## Natural Environment Referral Response - Biodiversity

Application Number:	DA2022/0786
Date:	21/06/2022
Responsible Officer	Nick England
Land to be developed (Address):	Lot 8 DP 21933 , 47 Hilltop Road AVALON BEACH NSW 2107

Figure 1.1. Extract from Arboricultural Impact Assessment. Source: raintree Consulti

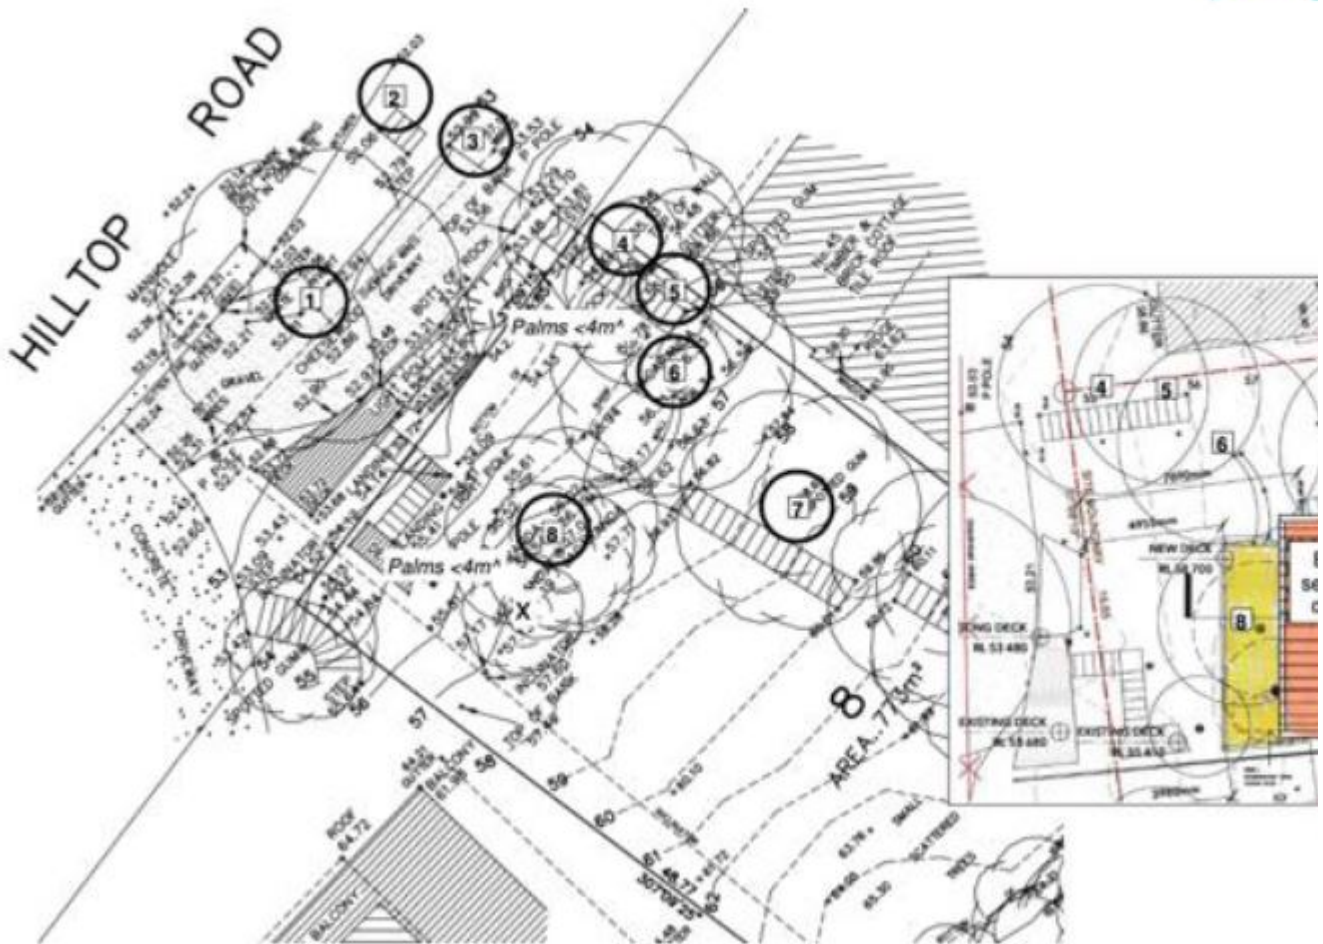
The application seeks to remove Tree 1 (*Glochidion ferdinandi*) located within the road reserve to accommodate the proposed driveway crossover. The Ecology Letter states that Tree 1 is located outside DPE's BV mapping, however, this statement appears to be contradicted by Figures 1.1 & 1.4. On this basis, the minimum submission requirements have not been met and the Biodiversity Referral cannot support the application. The applicant is encouraged to redesign to retain Tree 1, or

must provide a Biodiversity Development Assessment Report (BDAR).
